First floor plan scale: 1:50 at A1

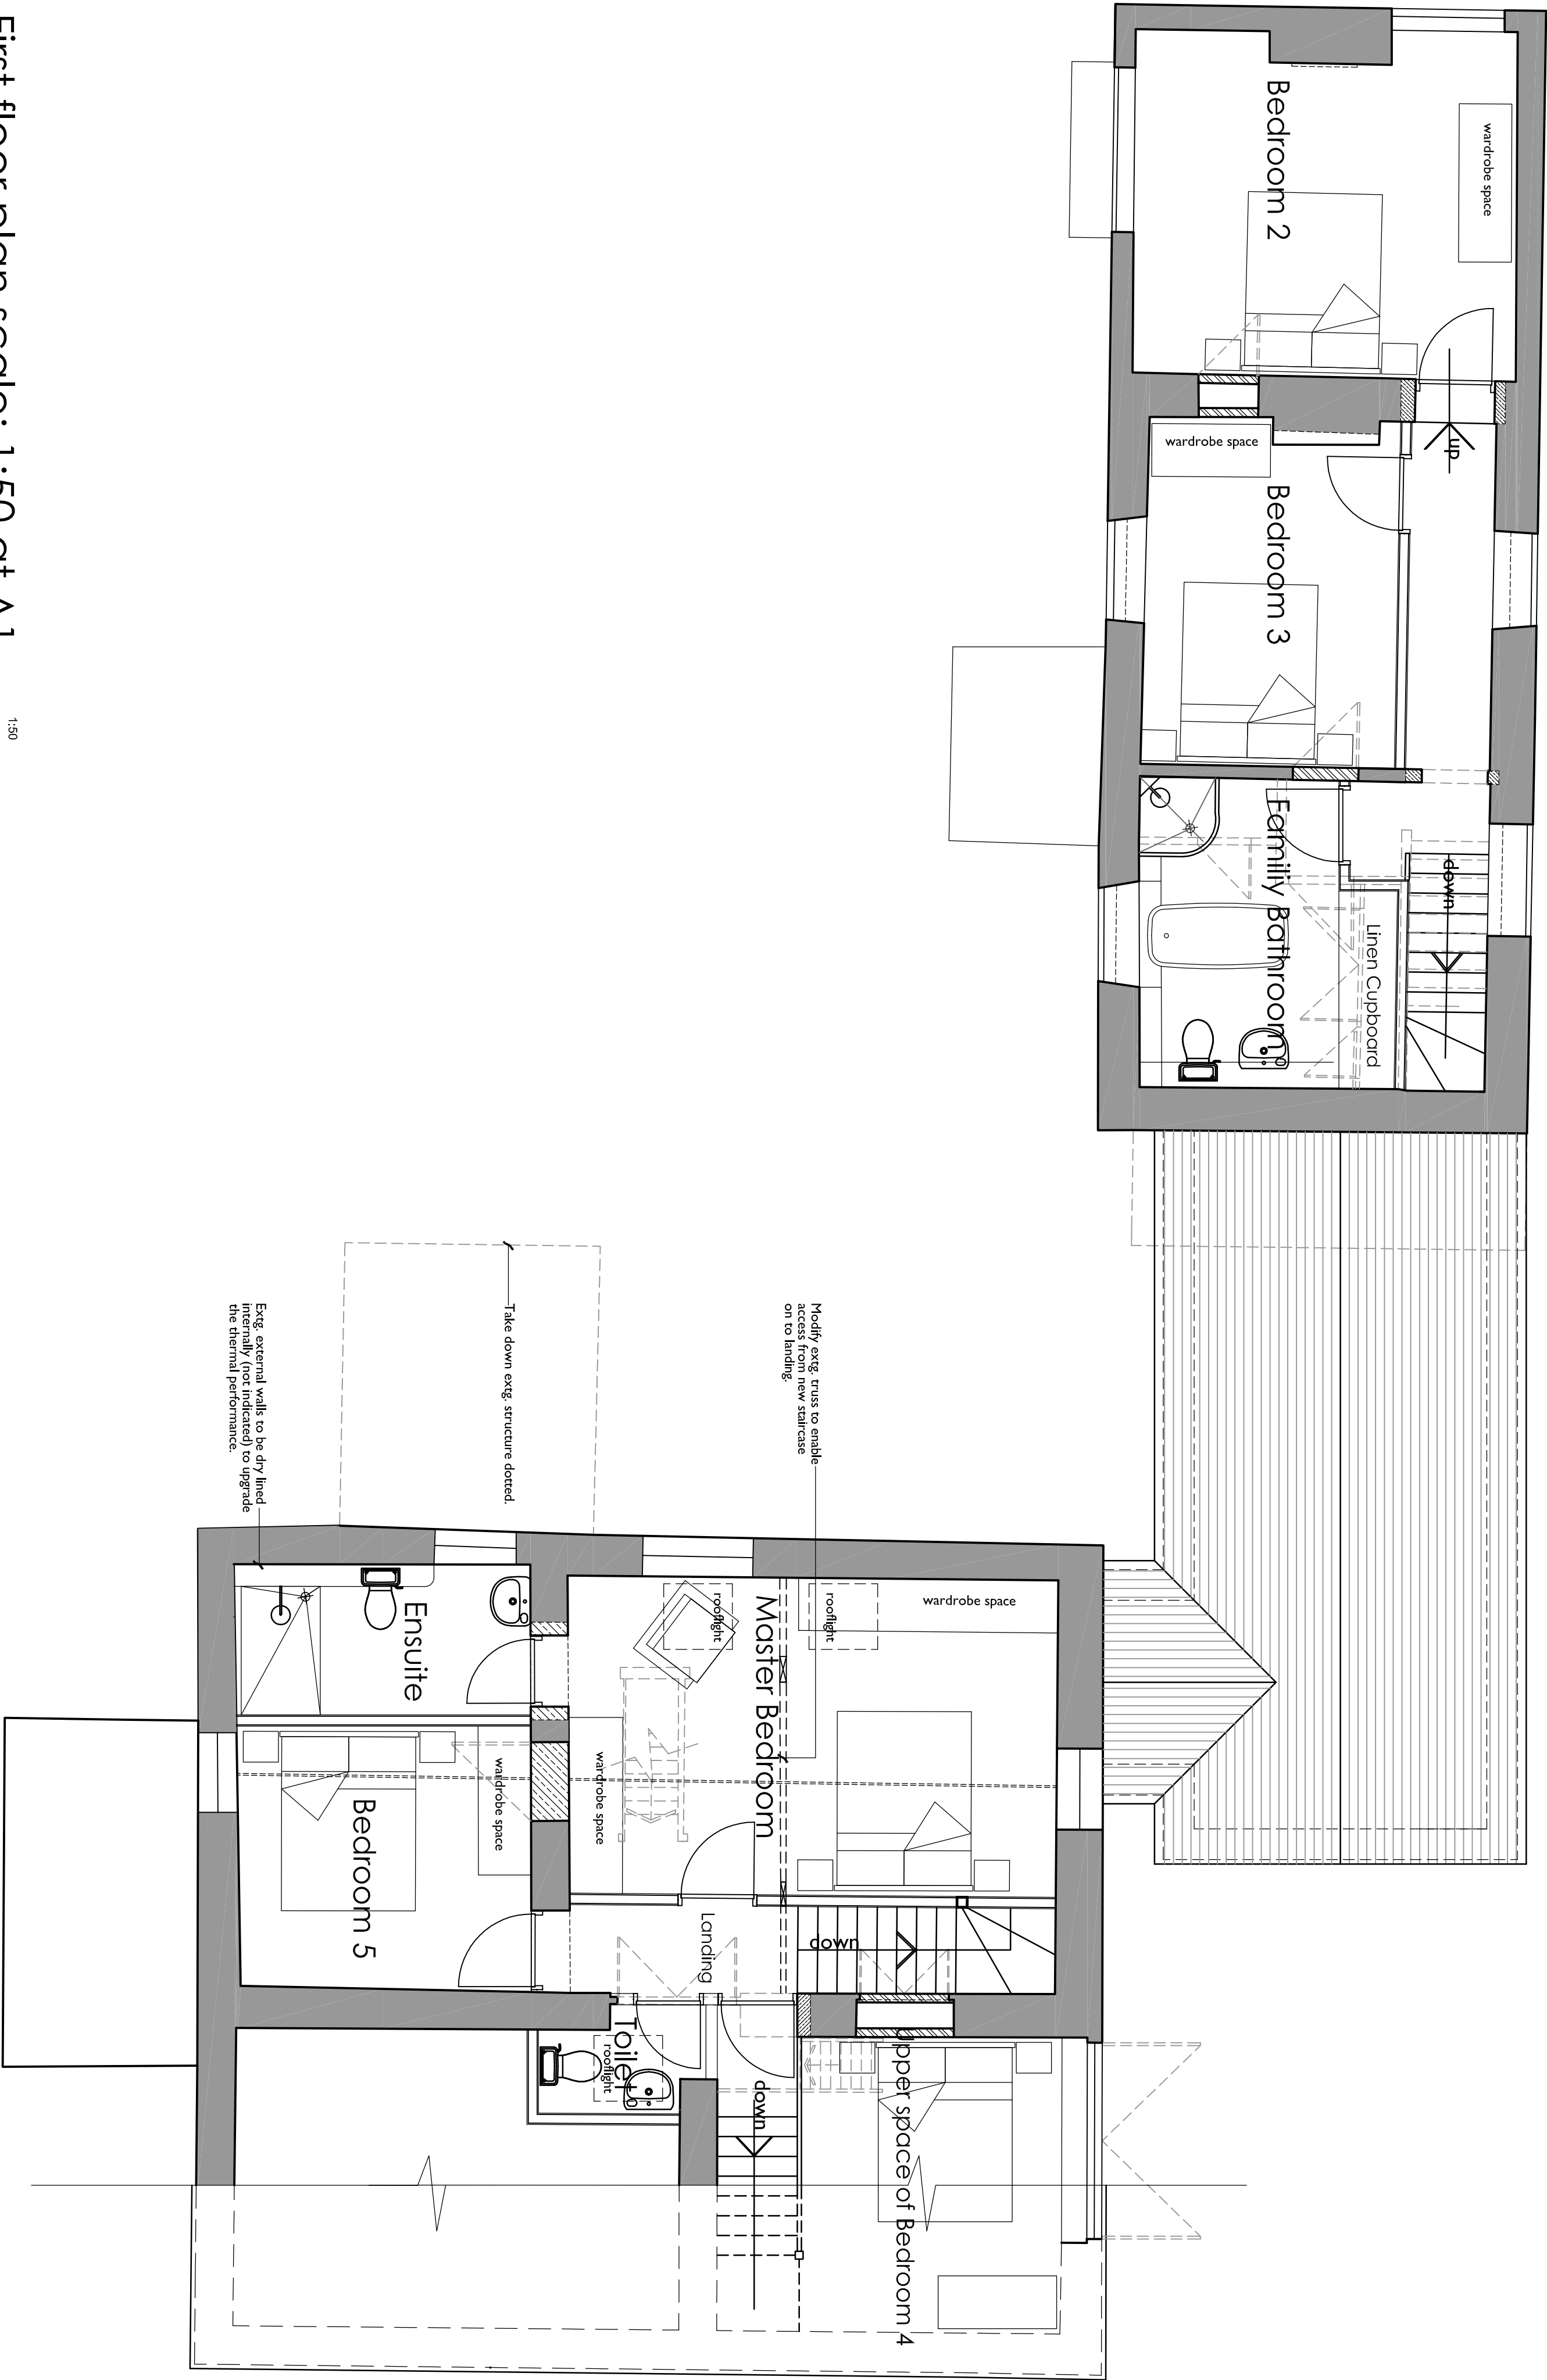
Rev	Down	Comments	Date
A	SM	Blank structure revised to reduce footprint 21.0k21.
